BLACKWATTLE BAY SSP

SUMMARY OF ISSUES AND RECOMMENDATION

The purpose of this review is to provide an urban design peer review of key matters from INSW's Blackwattle Bay State Significant Precinct (BWB SSP) proposal currently being assessed by DPIE.

Lot Consolidation

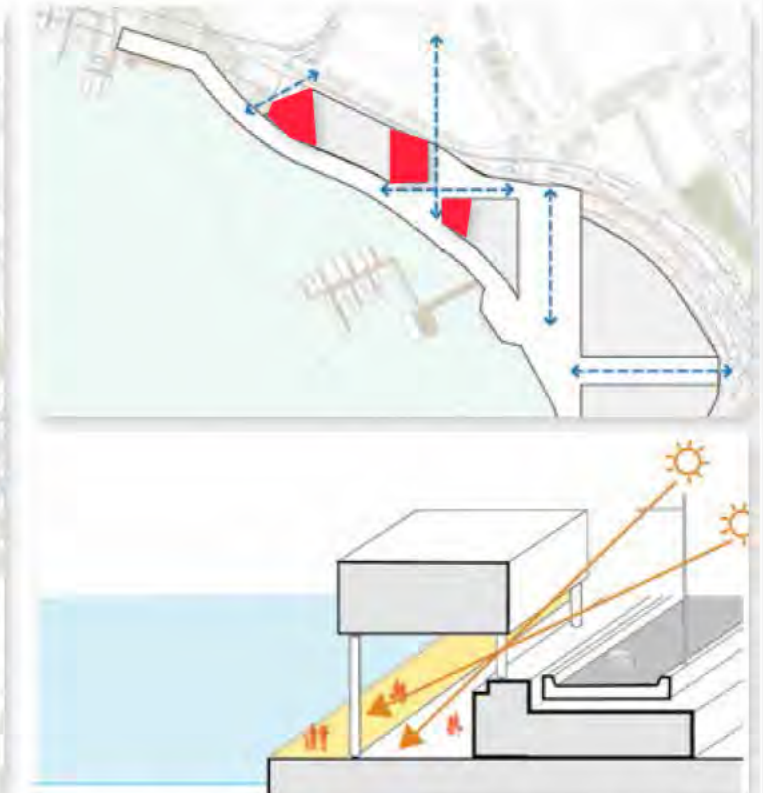
The current proposal includes several through site links with resultant small and constrained building envelopes. These building envelopes do not allow the generosity that would permit adequate articulation to improve amenity through detailed building design. Furthermore, the orientation of the through site links create wind tunnelling and poor solar access at the ground plane.

A consolidation of lots and a reduction in through site links as indicated above will improve internal circulation, amenity, experience at the ground plane and solar access, with a re-orientation of streets north south.

Potential Promenade Section

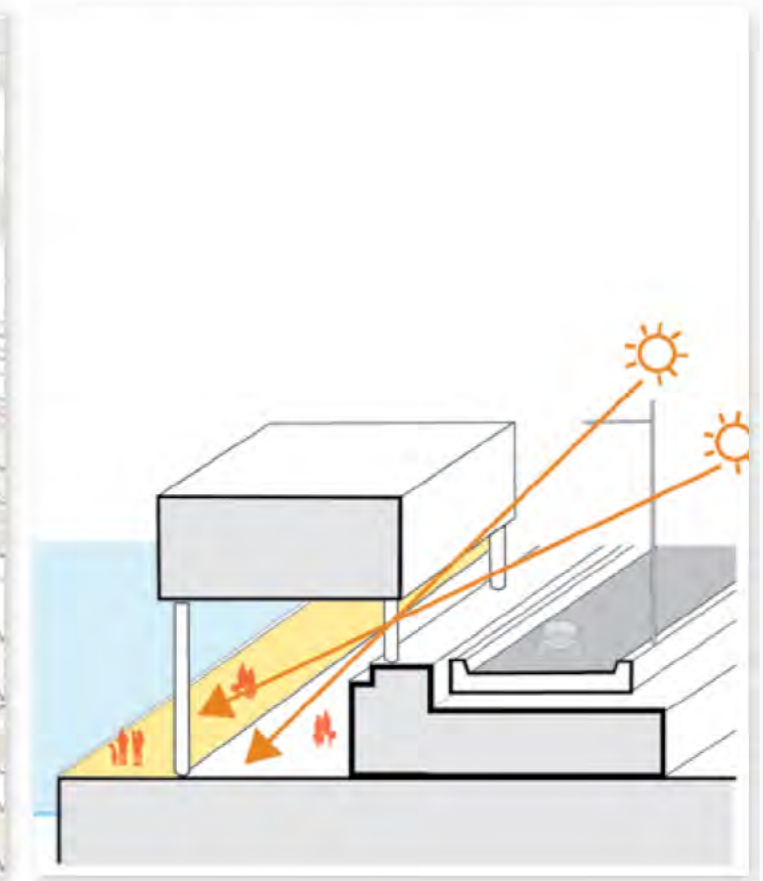
The section above shows an example of a building form approach that is separated from and cantilevered over the podium to enable light into the ground plane in areas that would otherwise be overshadowed by building height, bulk and scale, noting that issues such as noise, air quality and structural engineering would require consideration. An innovative approach to building design is essential for the protection of public space assets, whilst balancing land use and GFA.

Figure 1.1.25 / Extract of BWB SSP urban design statement noting outcomes in Character Area C (INSW with annotations by HASSELL)

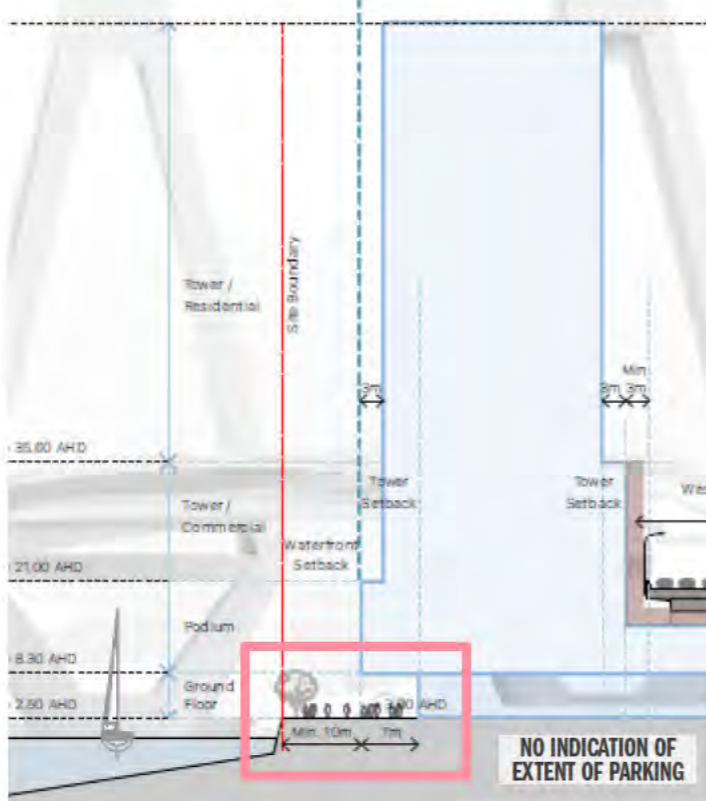
- A minimum 20m width at the water edge is required to provide access for walking, cycling, gathering and recreation.
- An additional 10m zone should be provided for dining and seating areas associated with retail uses and could be in the form of a colonnaded under-croft with a minimum 9m height.

Figure 1.1.26 / 3d View of BWB SSP proposal noting bay interface area and areas of proposed building which do not align with the PPPS objectives (INSW with annotations by HASSELL)

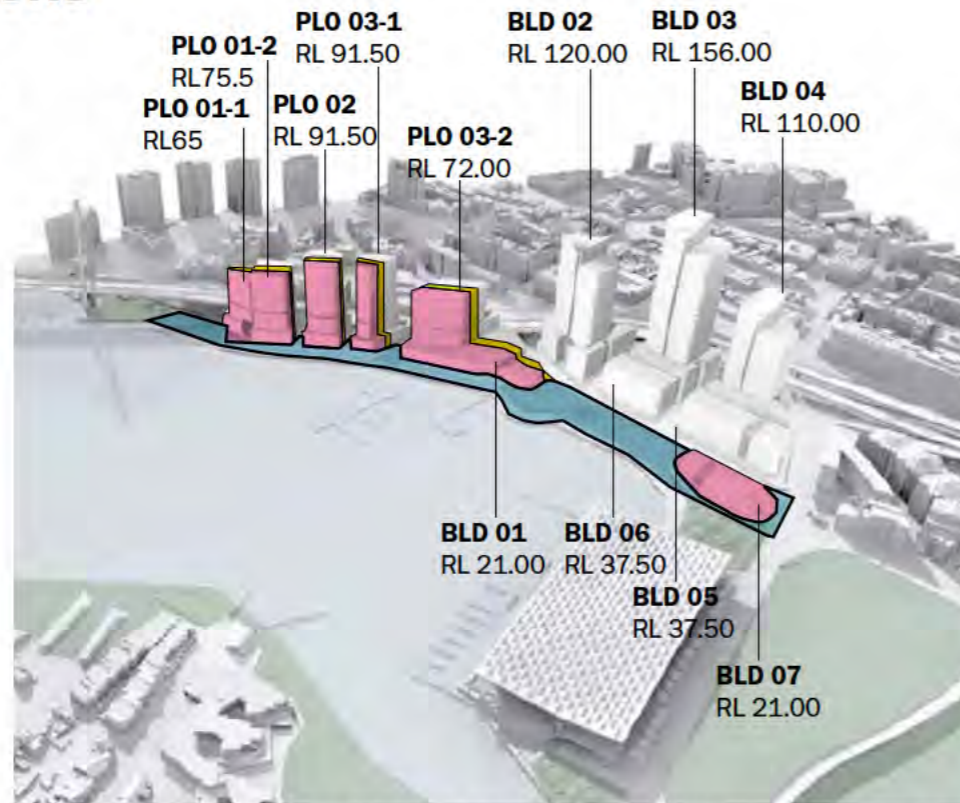
- a foreshore setback of 20m must be provided as public open space exclusive of dining areas
- an additional 10m zone should be provided where the orientation and adjacent use is appropriate for dining areas associated with retail tenancies potentially within a colonnaded under-croft (min 9m clear height)
- a further 30m of foreshore building limited to RL35 in height with taller buildings permitted in this zone only where clear public benefit and waterfront amenity is demonstrated.

Figure 1.2.28 / 3d View of BWB SSP proposal noting height transition area defined under the PPPS Height Strategy (INSW with annotations by HASSELL)

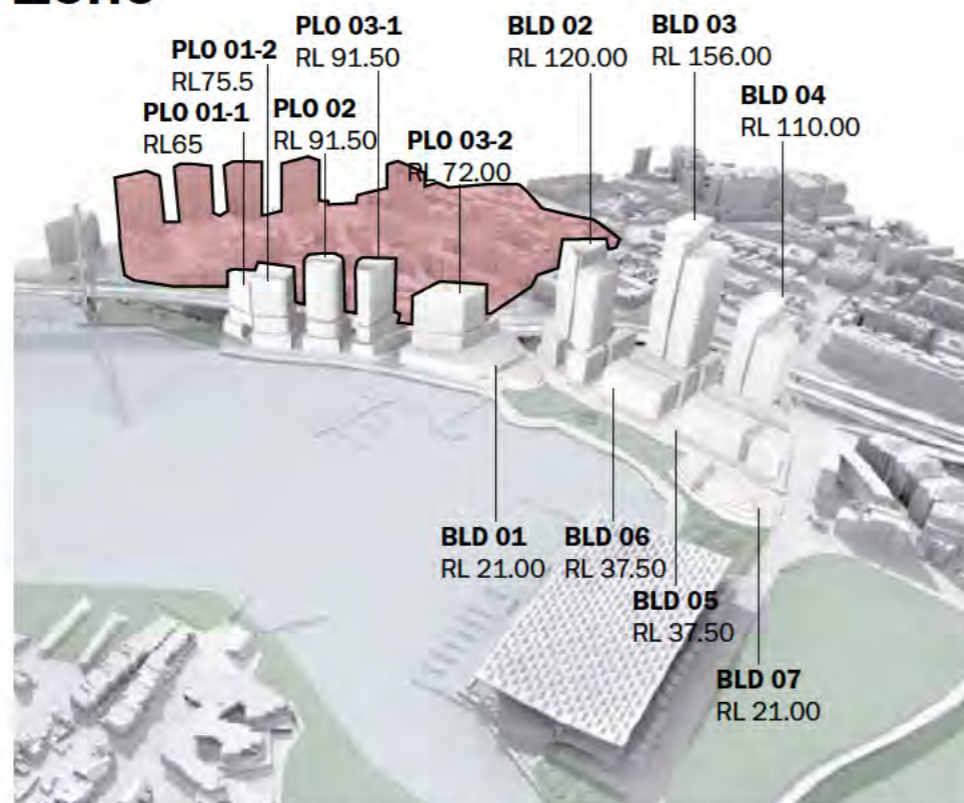
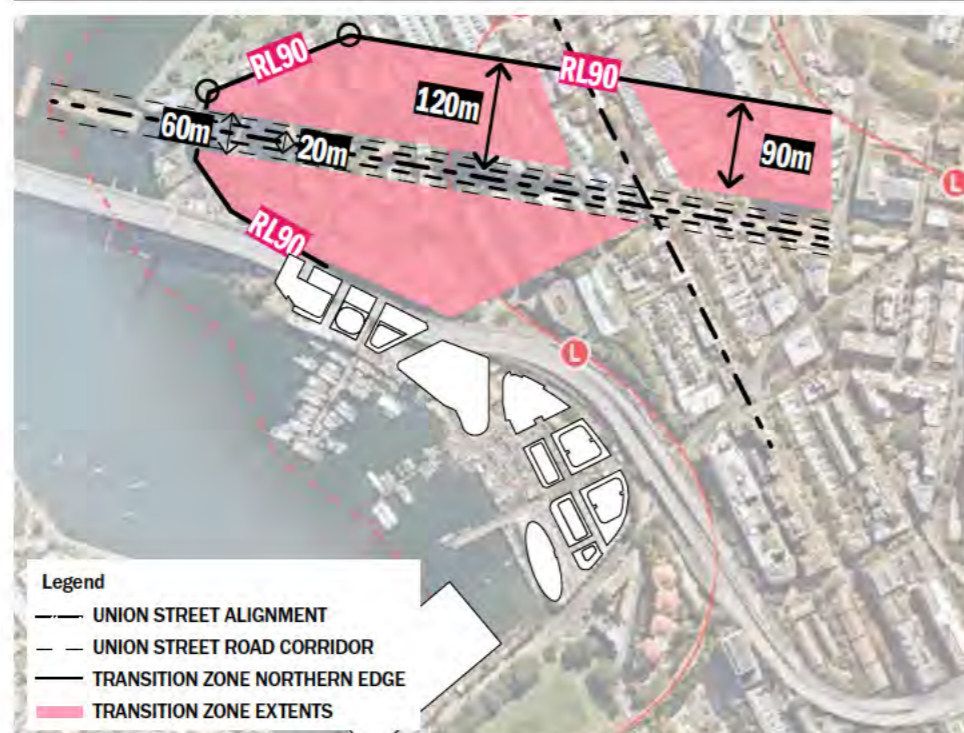
- a maximum height of RL90 along the northern boundary parallel with Union Street
- a maximum height of RL90 along Bowman Street reflecting the existing built heights at Distillery Hill
- a maximum height of RL90 along Banks Street between Bowman Street and Quarry Master Drive
- a potential progressive increase in height as the distance from Union Street and Miller Street reduces from the specified maximum.

Figure 1.2.30 / 3d View of BWB SSP proposal noting open spaces with defined amenity requirements under the PPPS Height Strategy (INSW with annotations by HASSELL)

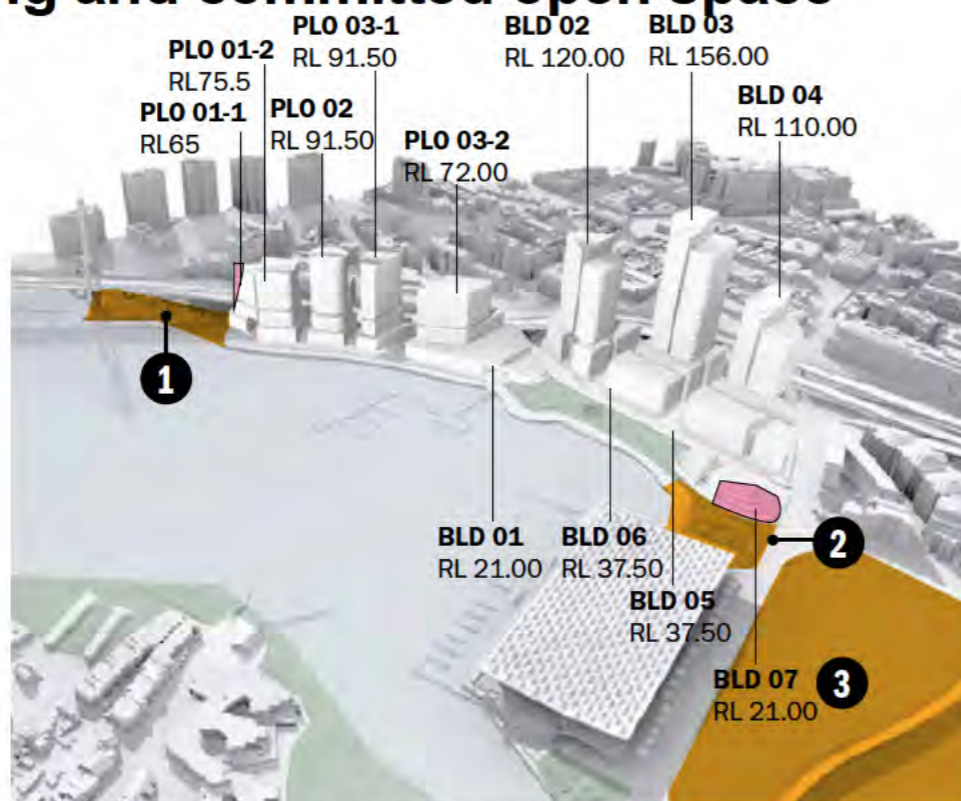
Name	Hours of protection
1 Banks Street Park	10am-2pm
2 Sydney Fish Markets Square	12pm-2pm
3 Wentworth Park	10am-2pm

Figure 1.2.33 / Plan of BWB SSP with analysis of number of hours sunlight to open space as a result of proposed built form and open space arrangement (FJMT)

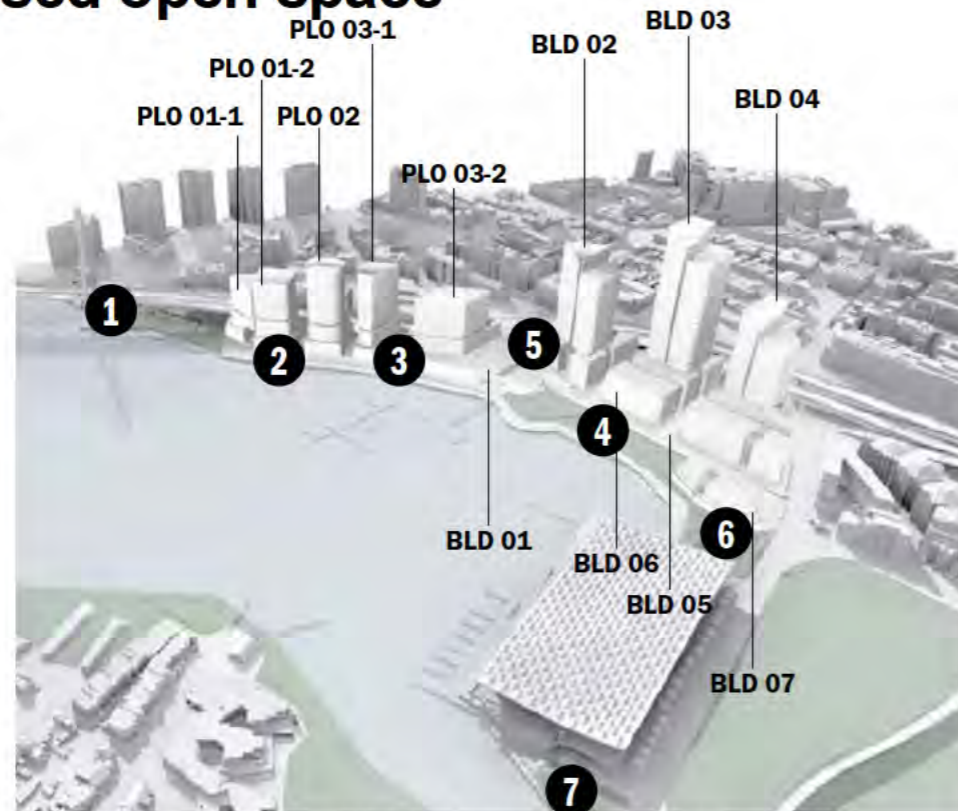
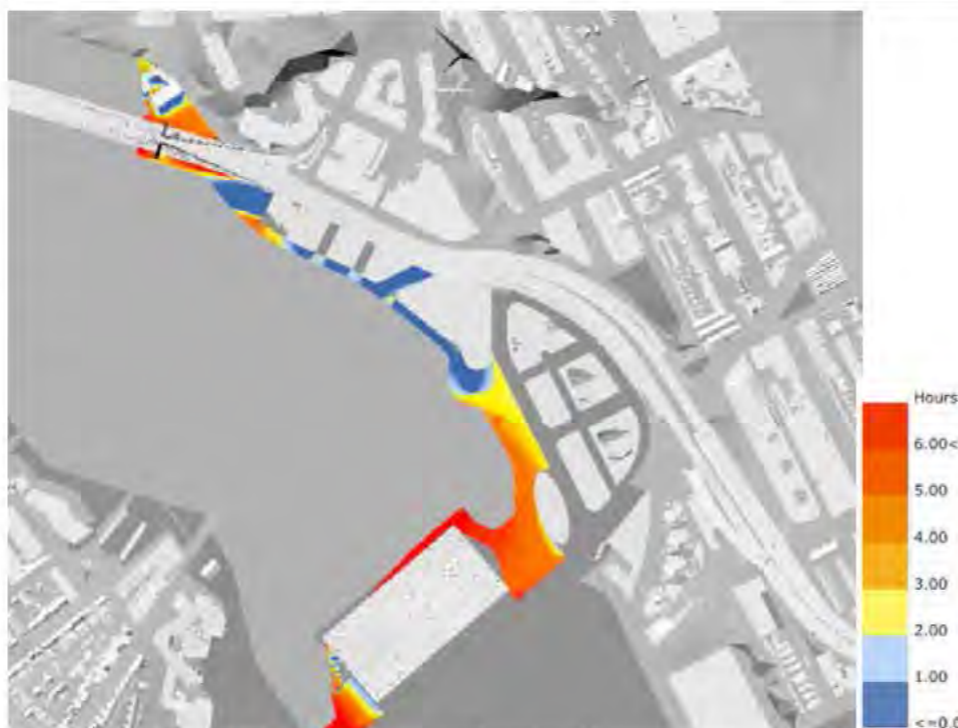
- A minimum of 2 hours sunlight to tree canopies is necessary to support growth
- A minimum of 4 hours sunlight to grass is necessary to support growth.

Figure 1.2.35 / Plan of BWB SSP showing outcomes of wind analysis following application of treatments highlighting areas where performance criteria are not met (INSW with annotation by HASSELL)

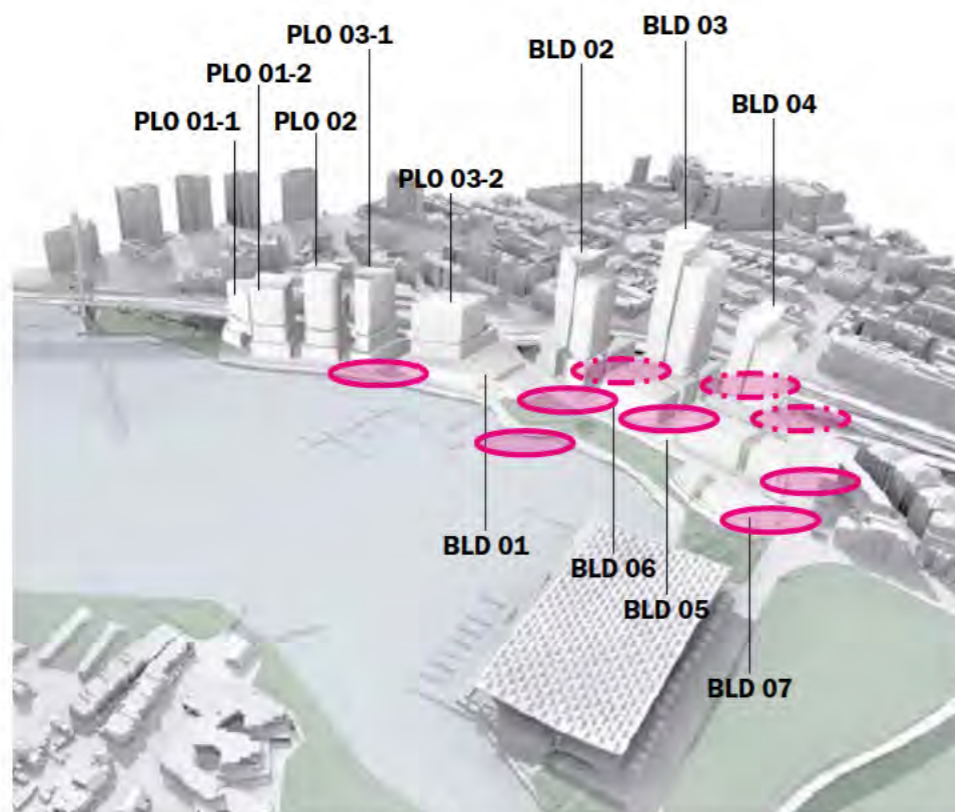
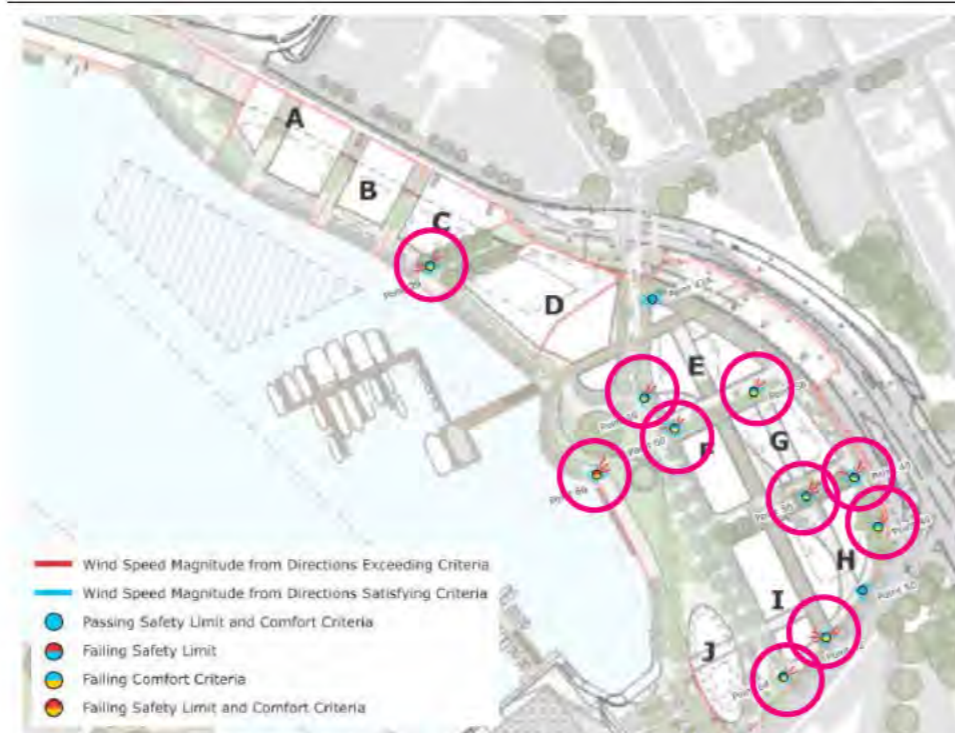
- All active retail frontages and open spaces should be able to support outdoor dining.
- All local streets should be able to support pedestrian sitting.
- All major roads should be able to meet pedestrian walking.

- The assessment undertaken by Windtech notes on Figure 5 that target criteria for all points are in accordance with "Draft Sydney DCP 2012 - Central Sydney Planning Review Amendment" as follows:
 1. Wind Comfort Standard for Walking Criterion of 8 m/s (5% exceedence) for walking
 2. Safety criterion of 24 m/s (gust - 0.1% exceedence) for safety.
- The assessment undertaken by Windtech on the proposed design with modifications for wind notes under Table 7 and Figure 8 multiple points which do not meet the identified comfort criteria for walking at multiple locations within and around the SSP and aligned to key pedestrian routes and unsafe wind conditions at the waterfront park.
- No locations are identified for sitting or outdoor dining under the minimum criteria to be met by the master plan design.
